Avolites LTD Engineering Change Notice

ECN title	DP2DVI supply from QVB		
ECN Number	ECN-0218		
Related Product(s)	QTZ with EEPD mobo; SN 03776-04152		
Date / Author	21/04/2023	GK	
Reasons for ECN	LEDs sometimes dim, losing license message on the screen		
Parts required	1221-2148REVA Qtz DP-DVI from QVB supply loom, 3x cable-ties		
Tools required	PZ2 driver, side cutters		
Estimated time	10 minutes

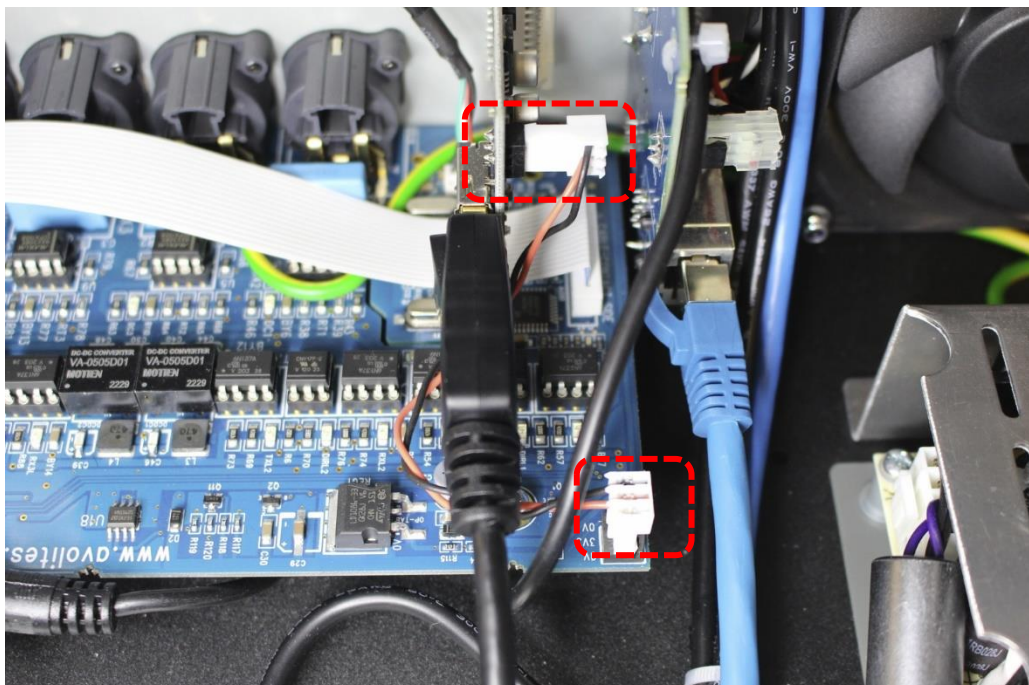
- c. Disconnect and discard the 2x 3way mascon connectors orange/black loom.

1. DP2DVI supply loom change.

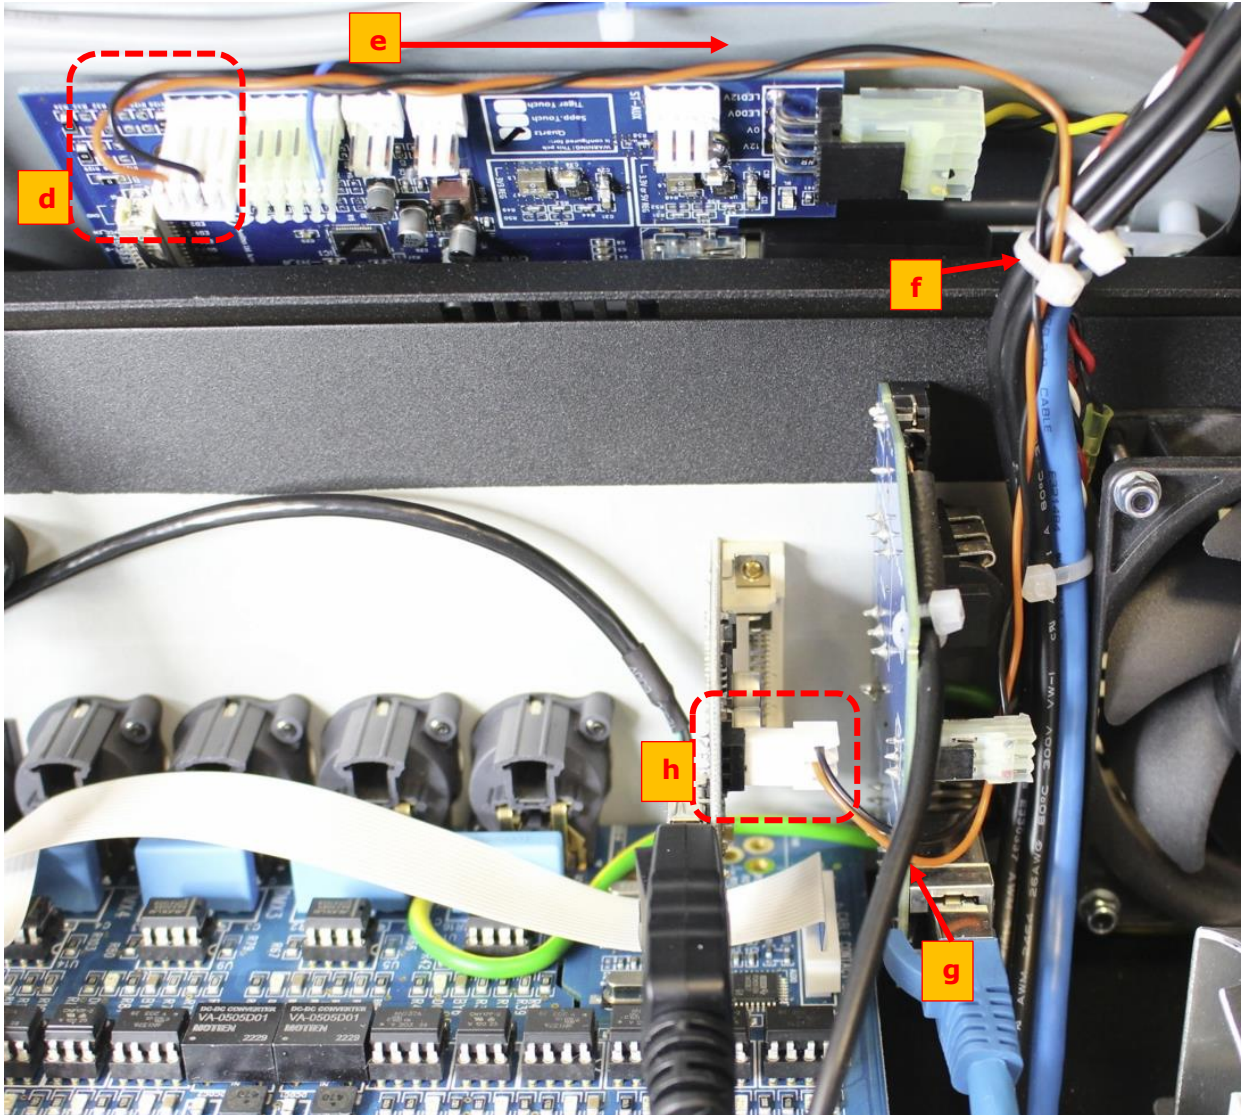
- d. Connect the 4way connector from the supplied 1221-2148 loom to **I2C** port on QVB board (leave a little slack on the loom as shown).
- e. Route the loom on top of the QVB board as shown towards the bunch of cables going from front panel towards the shell.
- f. Cable-tie the 1221-2148 loom to the bunch of cables.
- g. Route the 1221-2148 loom behind the audio loom.
- h. Connect the 3way connector to 3way header on DP2DVI board

2. FFC looms securing.

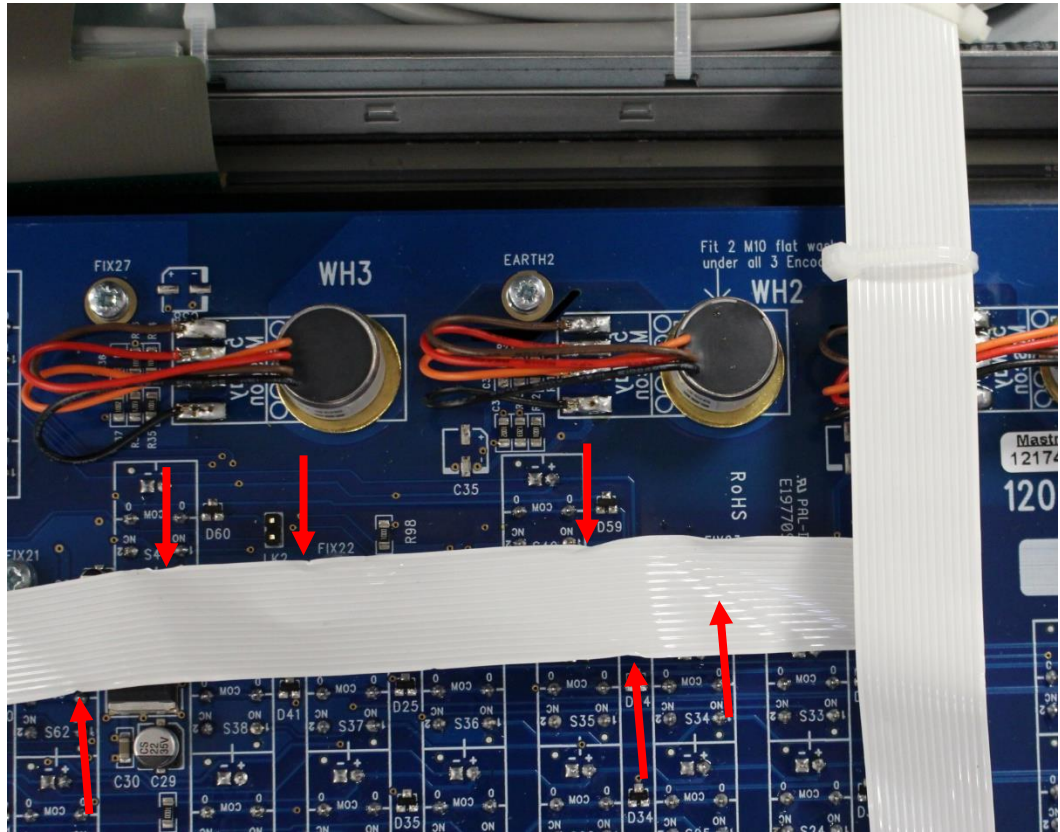
Reason for ECN: The FFC looms are getting damaged when the console is closing. FFC looms lose the predicted shape then they get trapped between the Front Panel and the Shell.

2.1 LK2 cut.

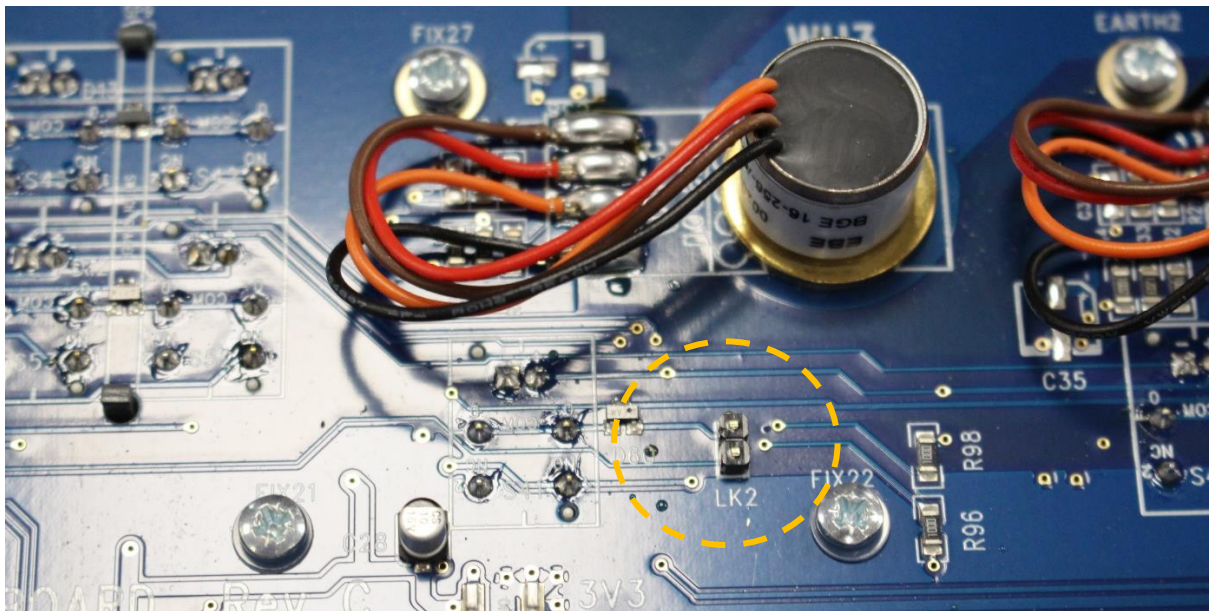
Cut off the two LK2 pins flash with the plastic part of the connector

2.2 FFC looms securing.

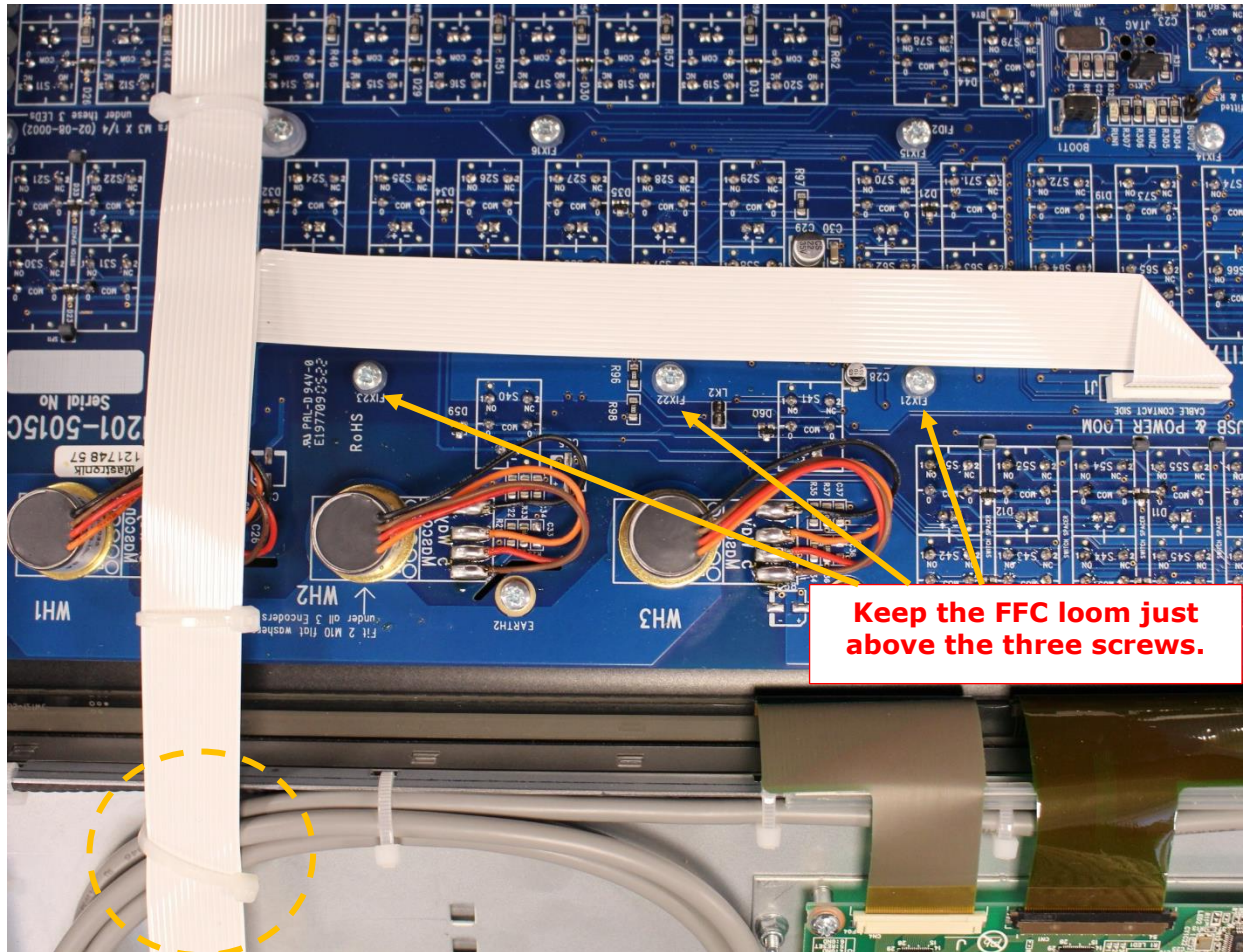
Just before the desk closing secure the FFC looms to the bunch of Touch USB looms with cable-tie as shown below.

NOTE: Do not fully tighten the cable-tie
